Application for Variation of an Environmental Permit

C1. Name of the Current Environmental Permit Holder :
Highways Department
C2. Application No. of the Current Environmental Permit : EP-541/2017
C3. The Current Environmental Permit was Issued in : month / year

**CE72/2015 (HY) Flyover from Kwai Tsing Interchange Upramp to
Kwai Chung Road**

Environmental Review Report

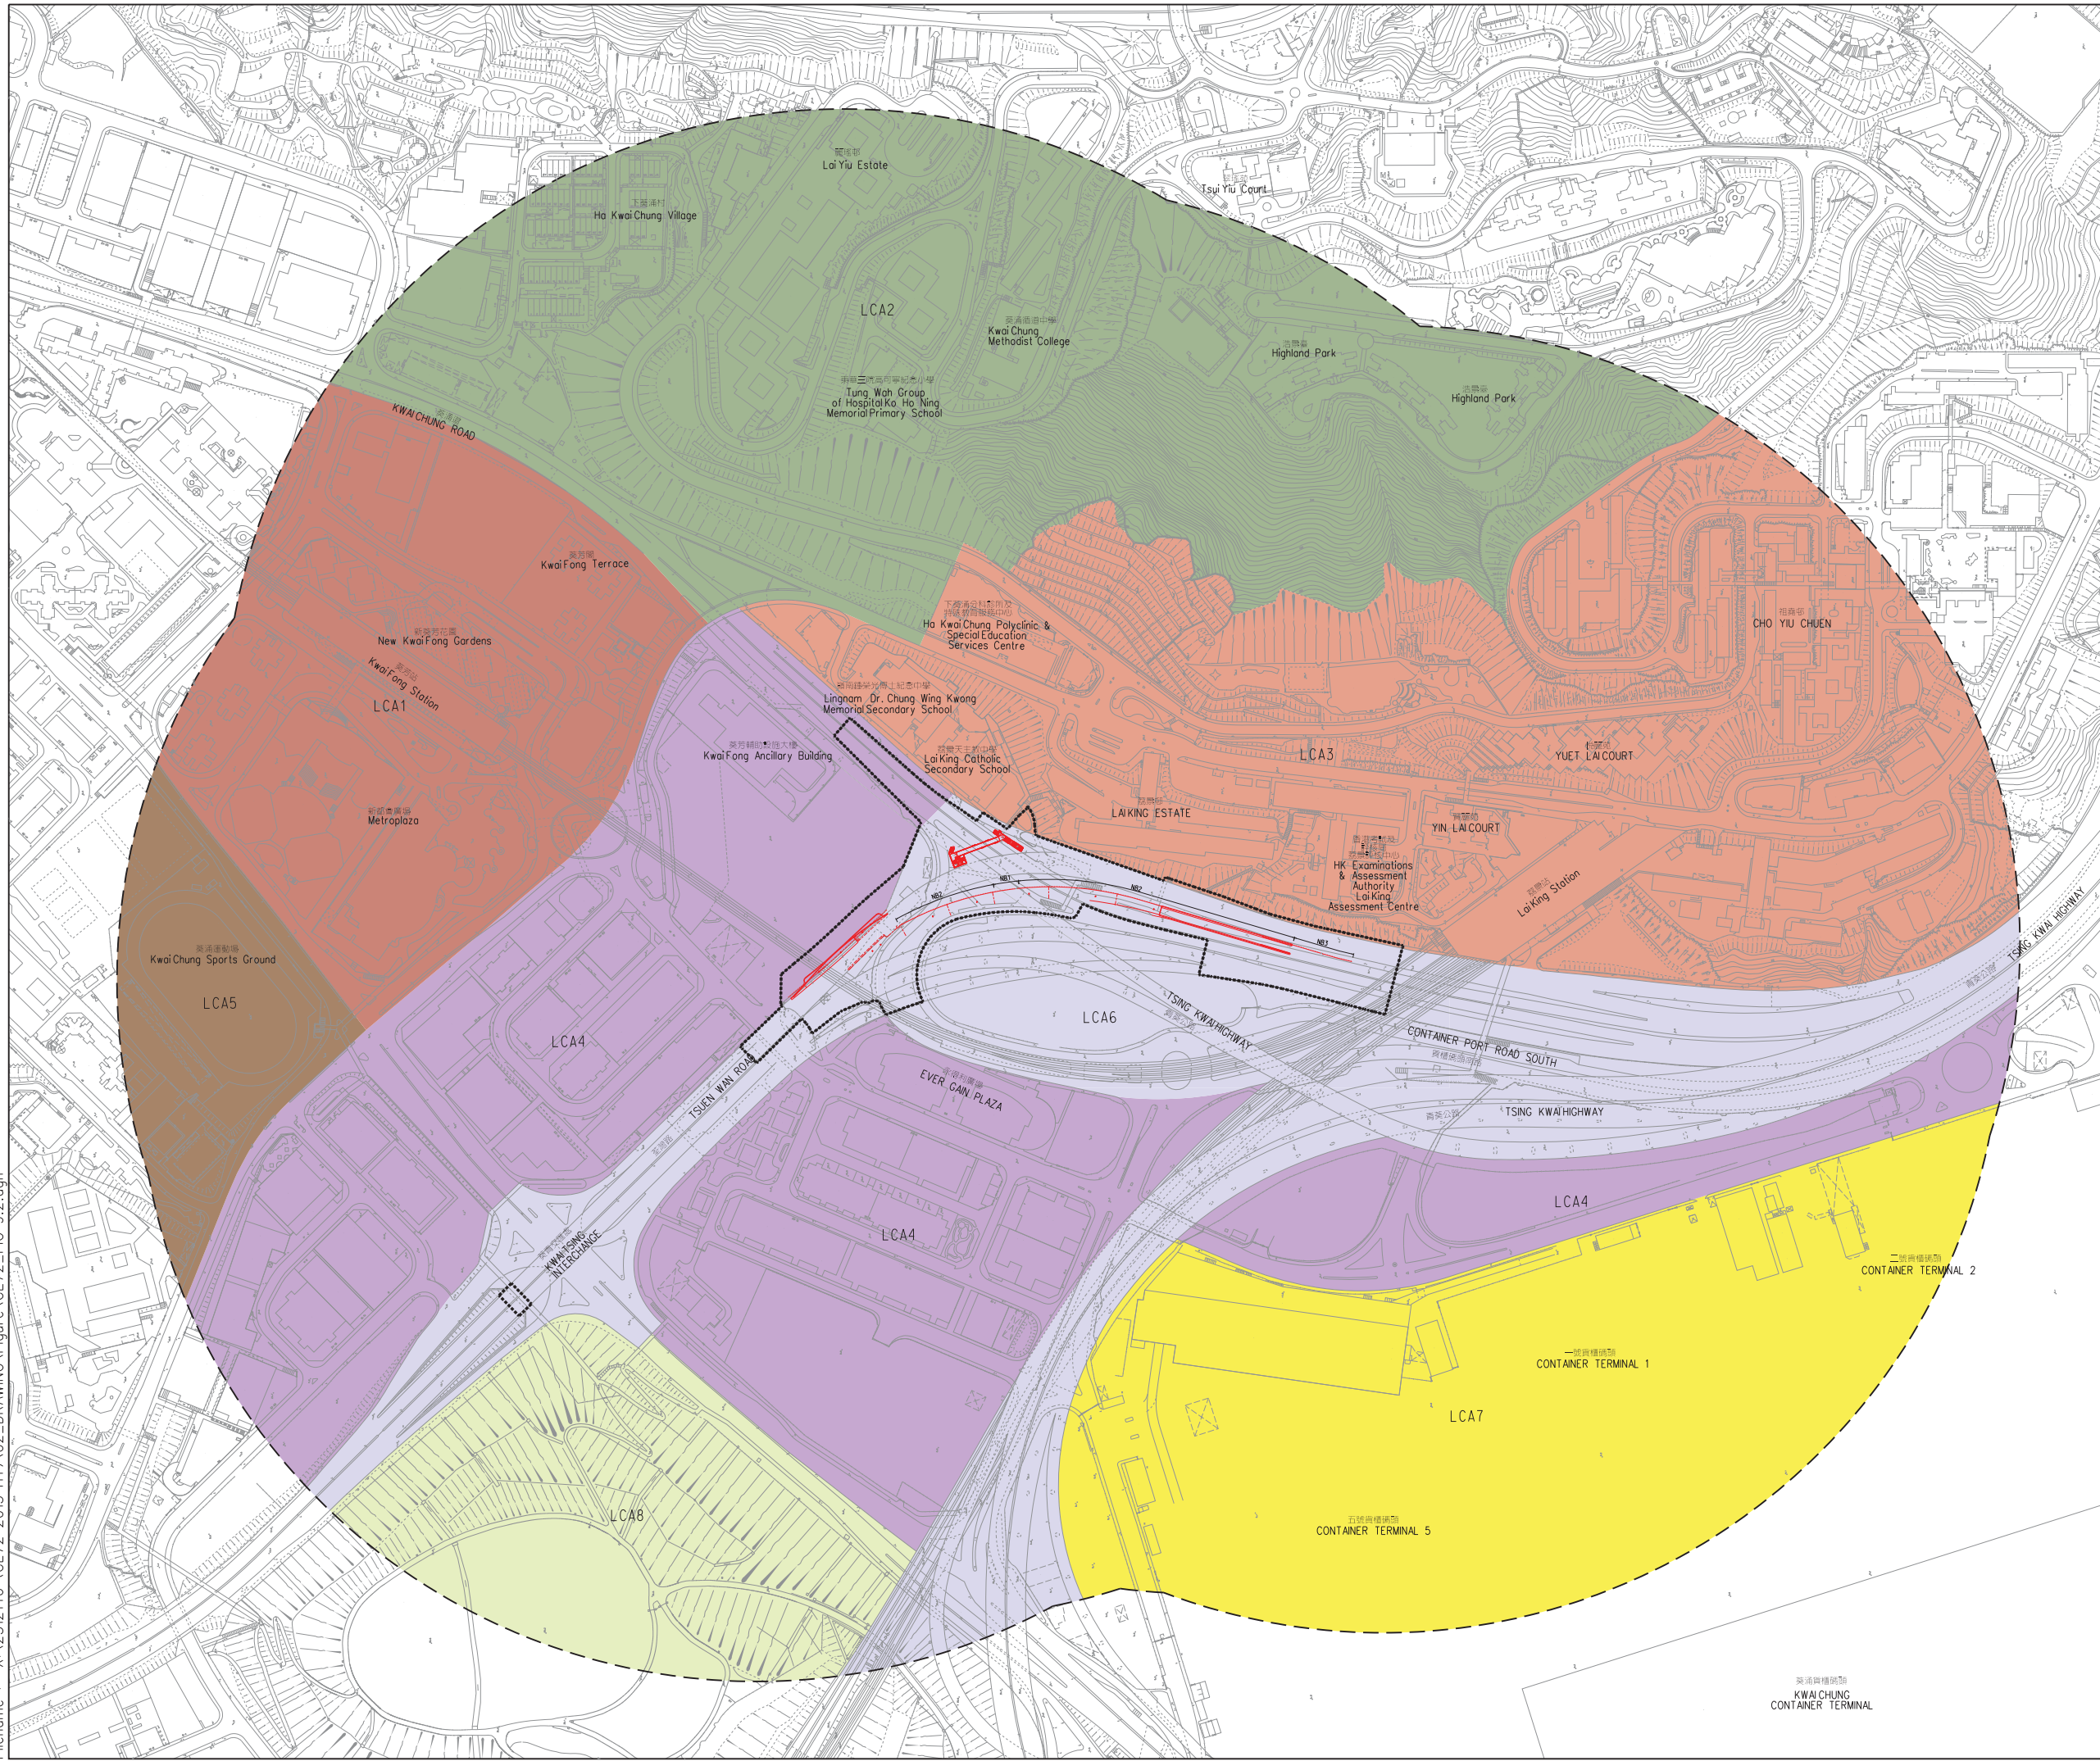
- 8.3.1 The extended areas have been overlaid to the Landscape Resources (LR) Plan and Landscape Character Area (LCA) Plan and shown in **Figure 8.1** and **Figure 8.2** and 1 LR and 3 LCAs will be affected. The recommended landscape and visual mitigation measures in the approved EIA Report is shown in **Appendix 8.2**. The location of these recommended mitigation measures will be adjusted to suit the proposed layout, but the recommended mitigation measures will remain the same as the approved EIA Report.

Drawing no.	FIGURE 8.3	Rev.	-
Drawn	CAD	Date	-
Scale	1:5000 (A3)	Checked	-
		Approved	-
		Status	-

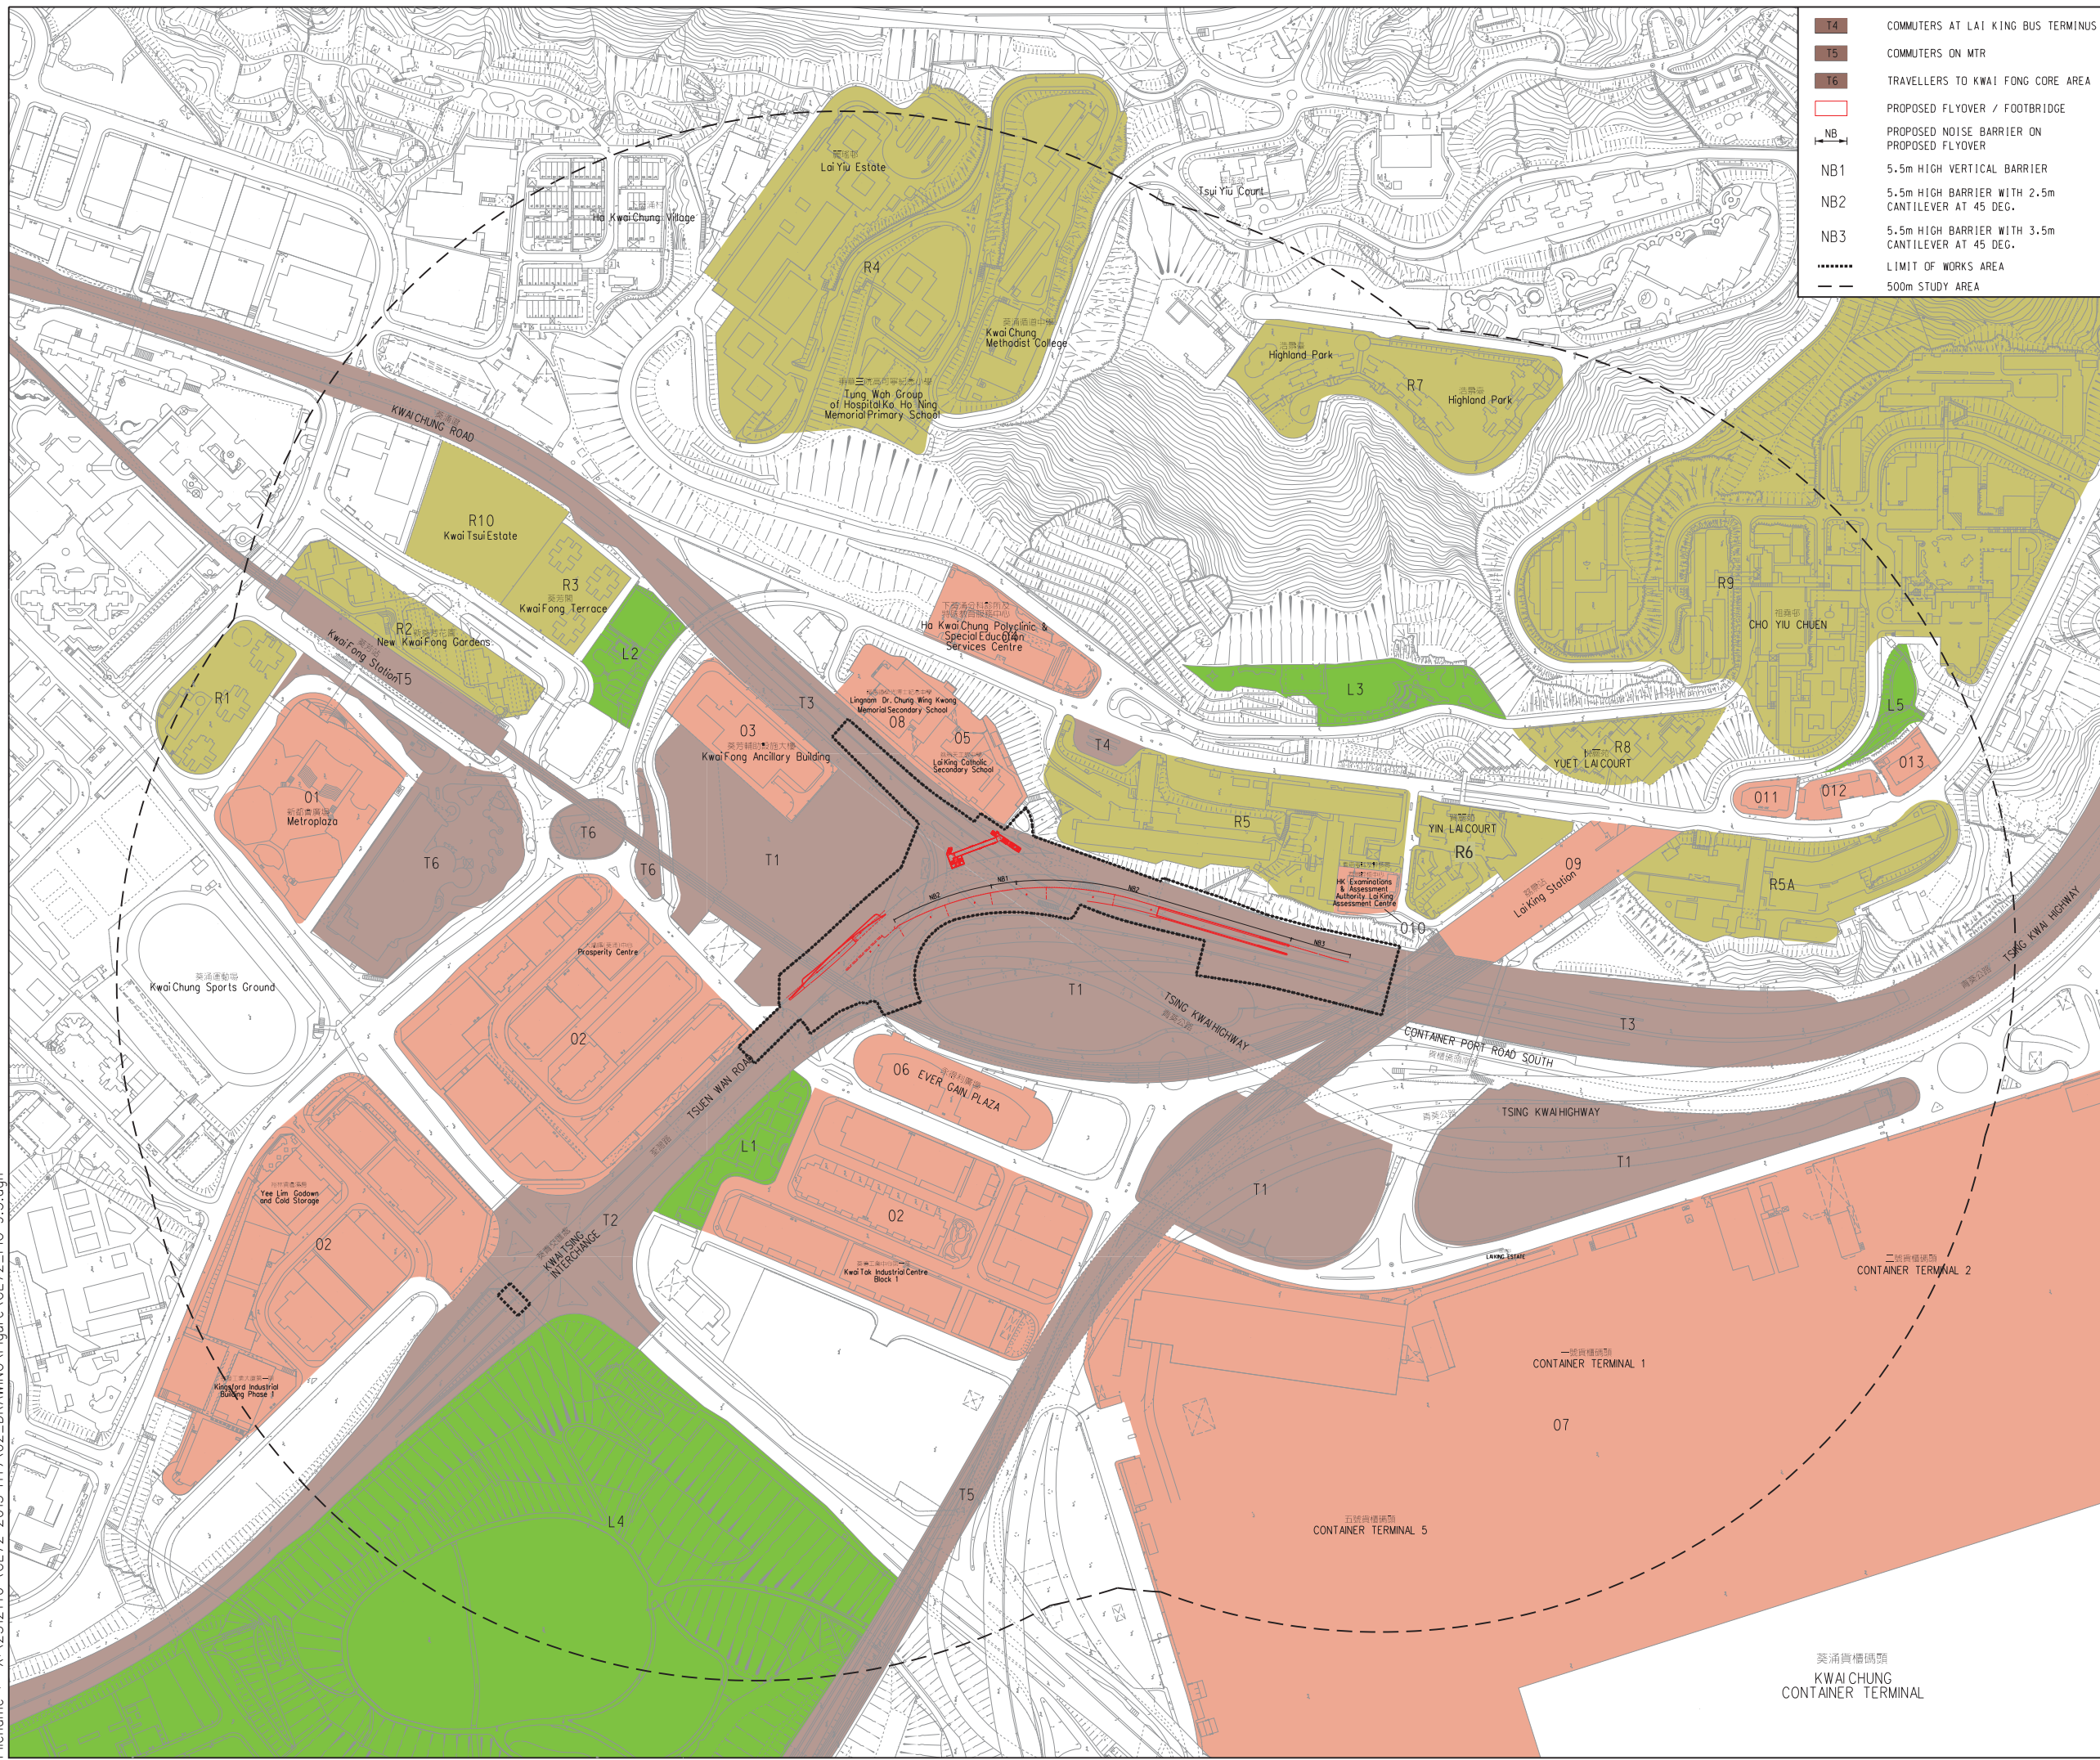
8.4.1 The extended areas have been overlaid to the Visual Sensitive Receivers (VSR) Plan and shown in **Figure 8.3**. Aside from the identified VSR affected in the approved EIA Report there will be an additional 2 nos. of VSR (R2 and R3) affected.
